Model Series 463 AMG: Active Distance Assist and
Active Brake Assist IC Message and DTC U0416FE

Topic number	LI54.71-P-078112
Version	4
Function group	54.71 - Camera and radar-assisted assistance systems
Date	7/8/25
Validity	463 AMG
Reason for change	Adding parts for wiring.

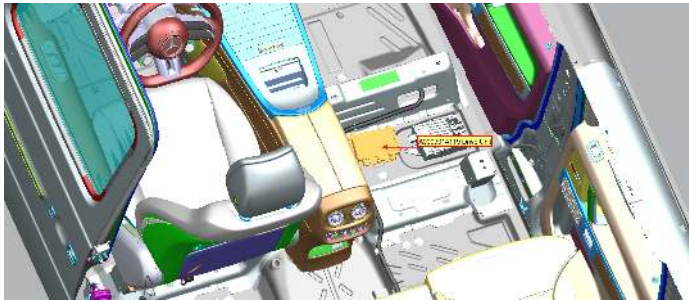
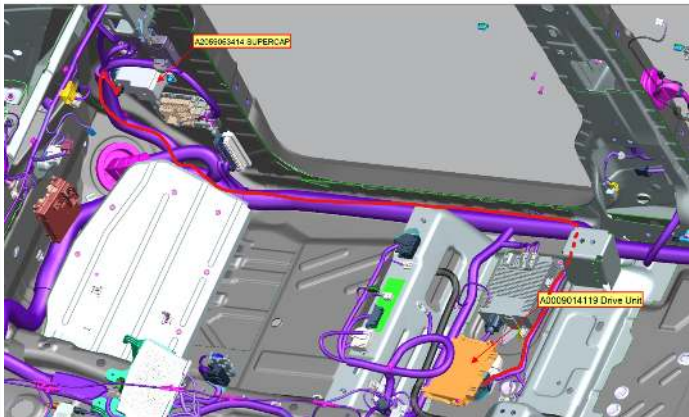
Missing wire between Drive Unit (N145) and Supercap (C8).

Professionally create a new connection by:

- Using a red/white cable with cross-section 0.35 mm² and overall length of approximately 2m.
- Connect Drive Unit (N145) plug A pin 18 to the 3-pin plug of the Supercap (C8) terminal 15 pin 2. Reference the new wire routing location as shown by the red line in "Picture 1 - Connection from Supercap to Drive Unit".
- The new wire should be added to the existing wiring harness as shown by the red line "Picture 1 - Connection from Supercap to Drive Unit".
- Z-Splice is the preferred method using A 000 982 91 10.
- Crimp Contact Pin (MLK) for the Drive Unit (N145) is A0485450328.
